## ADDENDUM #1

AUDREY J. WALTON STADIUM  
TRACK AND SOCCER SURFACE UPGRADE

PROJECT NUMBER: CP252172

Crockett Engineering Consultants  
1000 W. Nifong Blvd, Bldg #1  
Columbia, Missouri 65203

ALTERNATE #1 -  
SOCCER  
PRACTICE FIELD

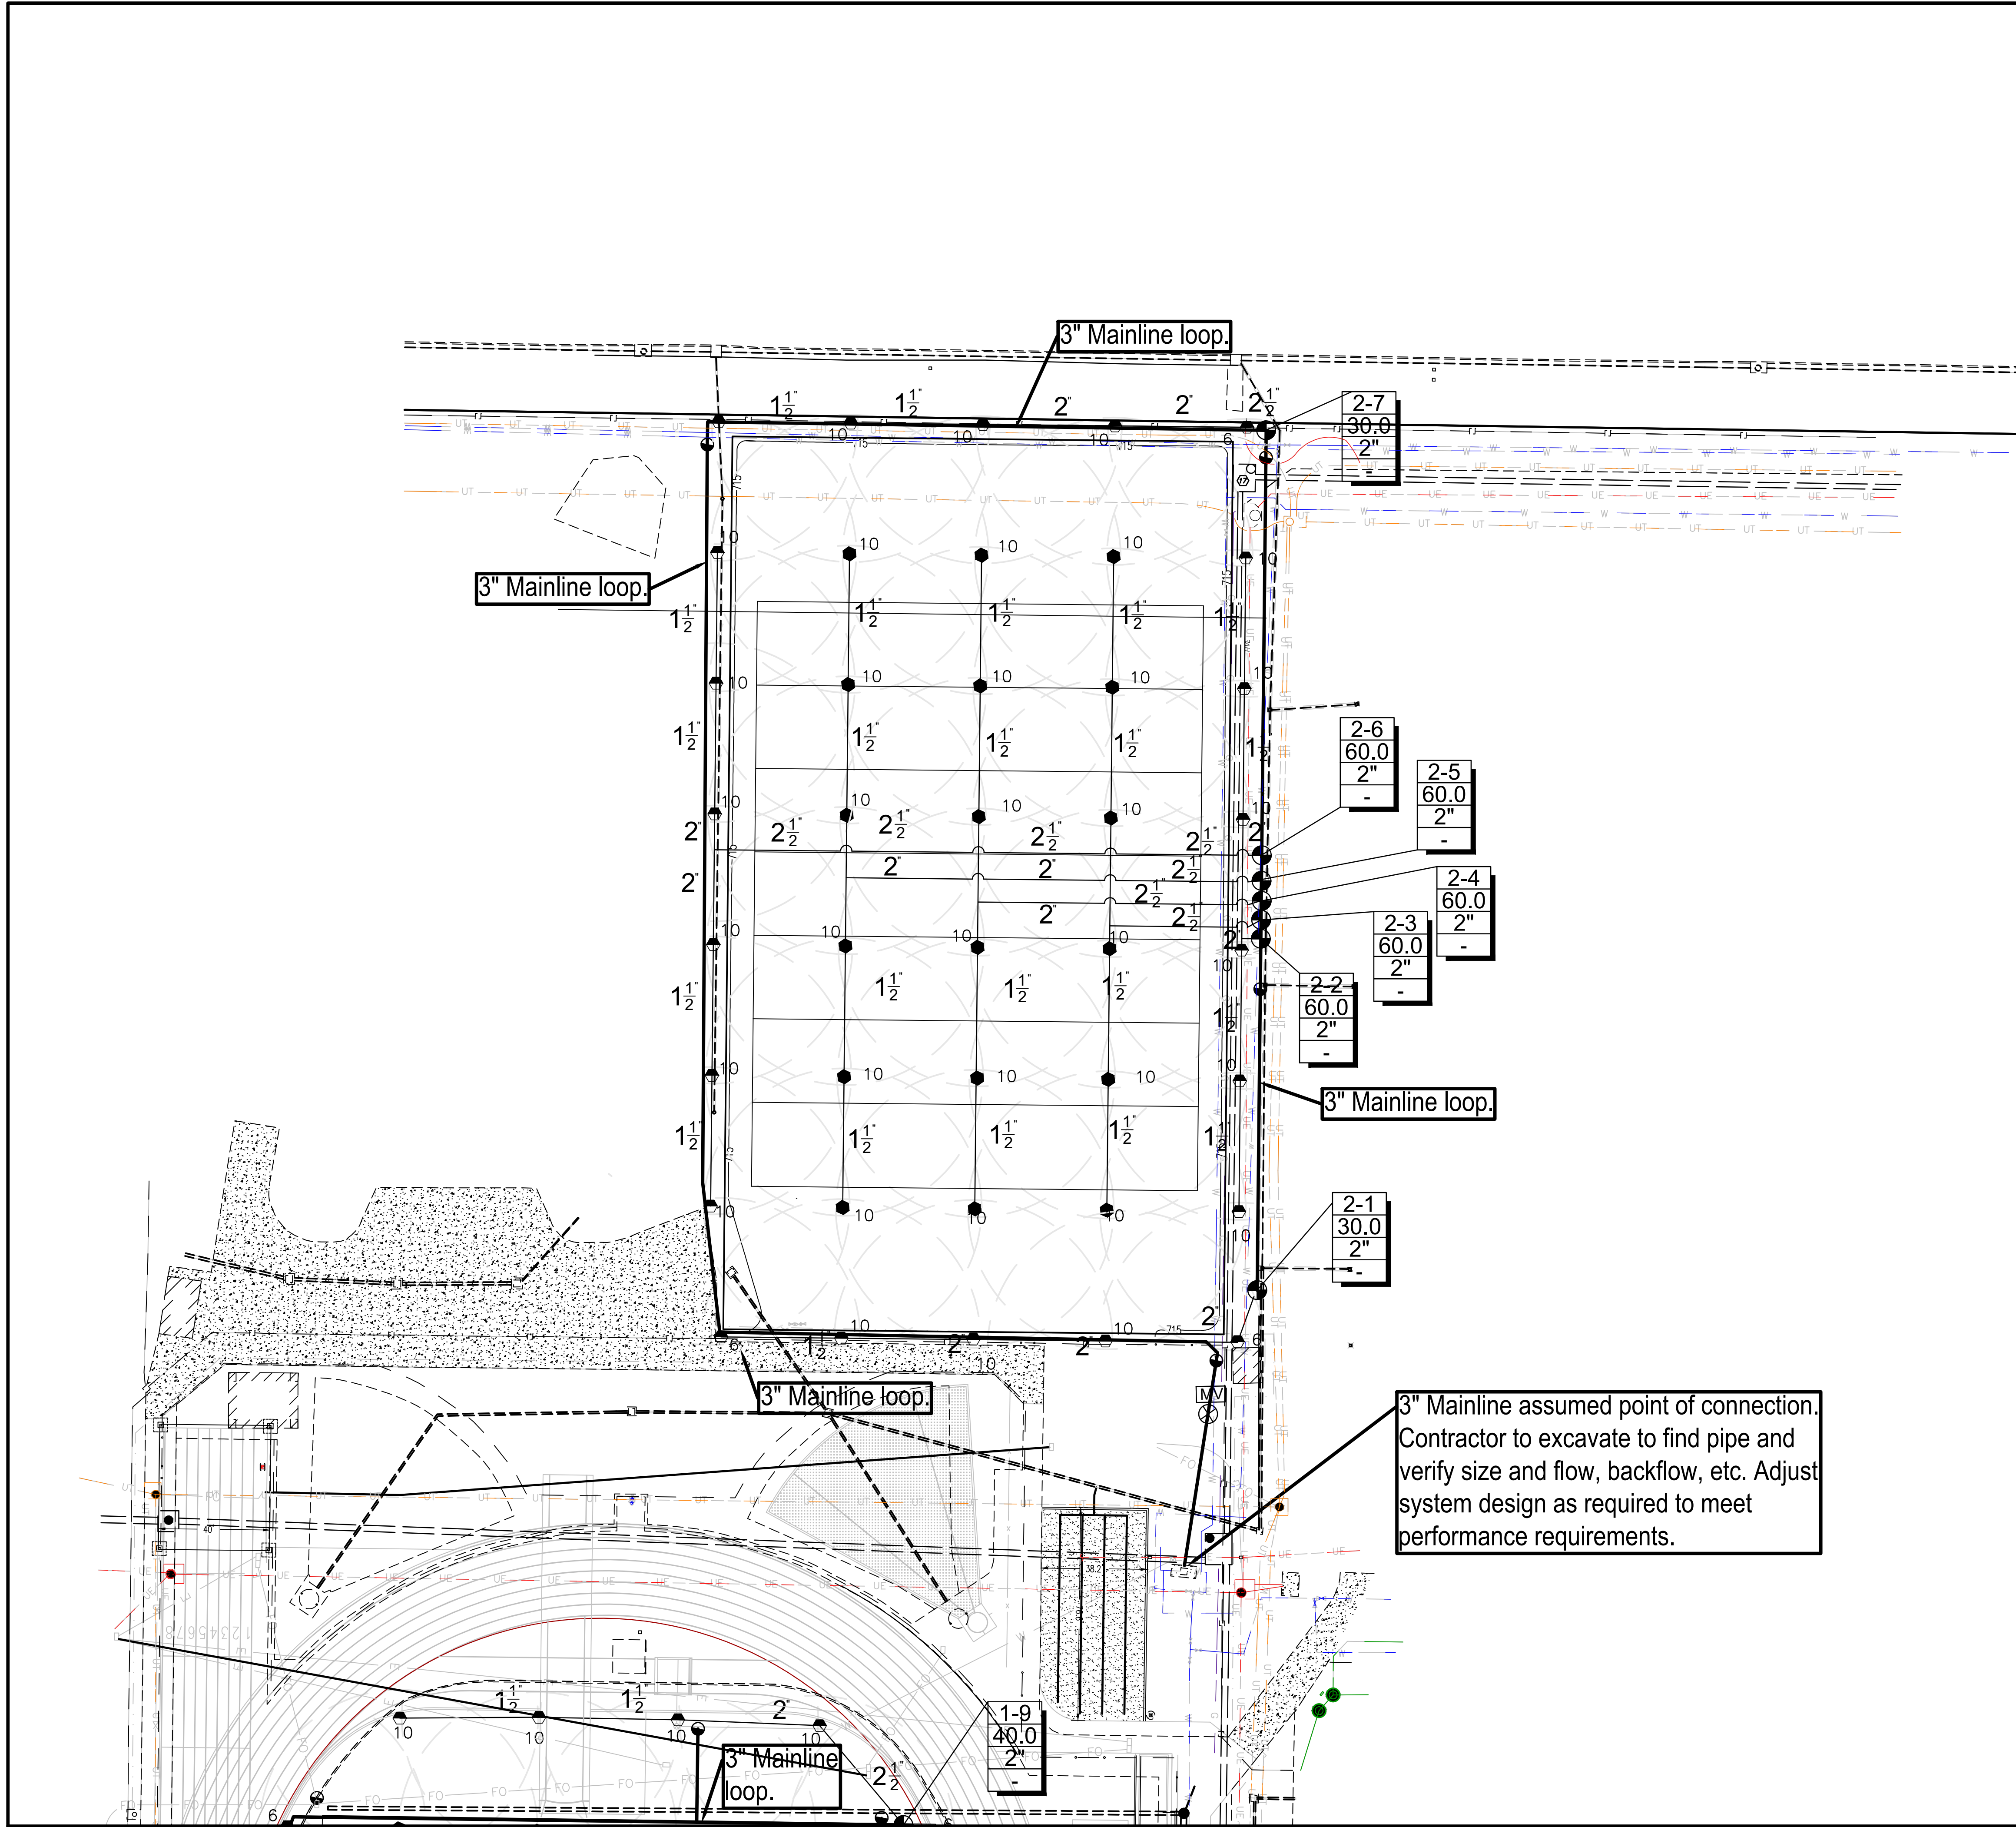
23. Comment: We couldn't identify the final grade plan or notes within the plan for the soccer field, Alternate 1, please clarify.

30. Comment: Does the Alt 1 soccer practice field require a growth blanket?

The final grades are shown on Sheet CE 8.0 and label around the field with the elevation followed by "FG" (finished grade). The existing grades are shown per the contours on the same plan.

Yes. Please refer to Note 3 on Sheet CE 8.0 that references the growth blanket and roller system.

8. Sheet CE 8.0 – Revised to show the existing field goal post.
9. Sheet S100 - Removed unneeded specifications and updated special inspections
10. Sheet S200 – Updated plan dimensions, added plan note, updated detail F10, and added Typ. Camera Pole Foundation Detail
